## **REMARKS**

### **Present Status of Application**

FIG. 3

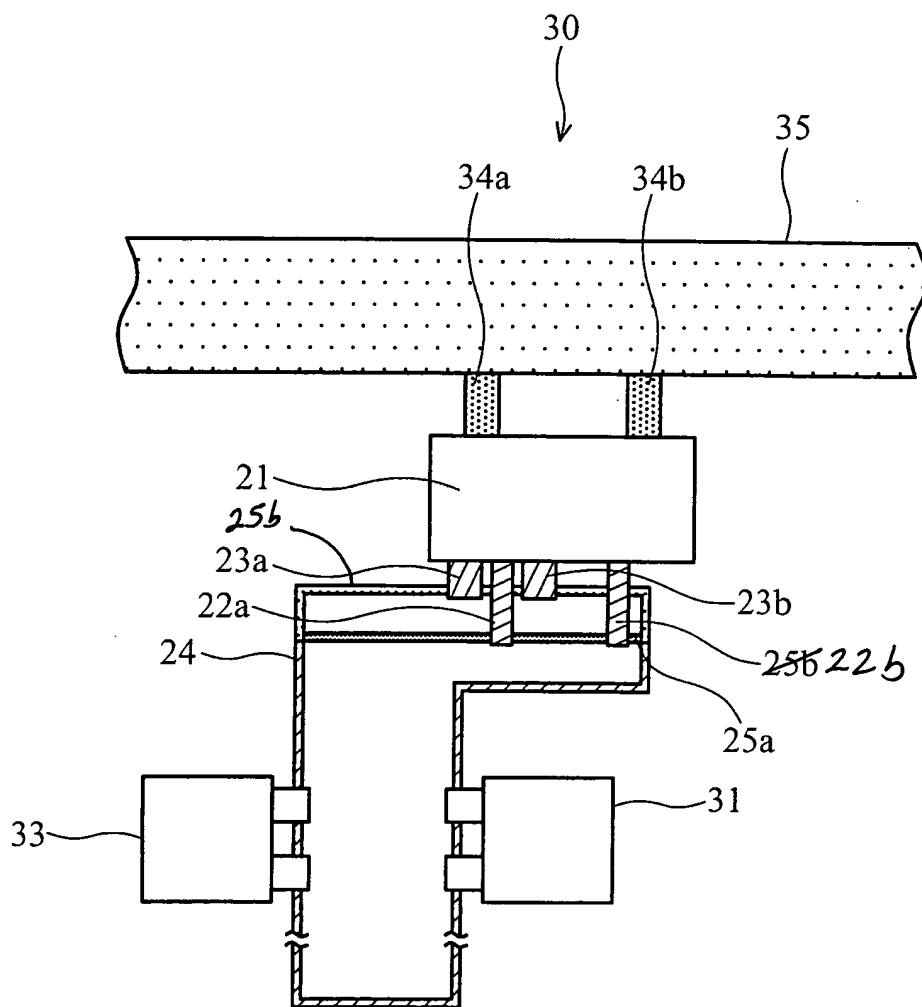
In FIG. 3, reference number 25b has been changed to 22b and a new reference number 25b has been added, as shown in the accompanying drawing sheets (both annotated drawing sheet and replacement drawing sheet).
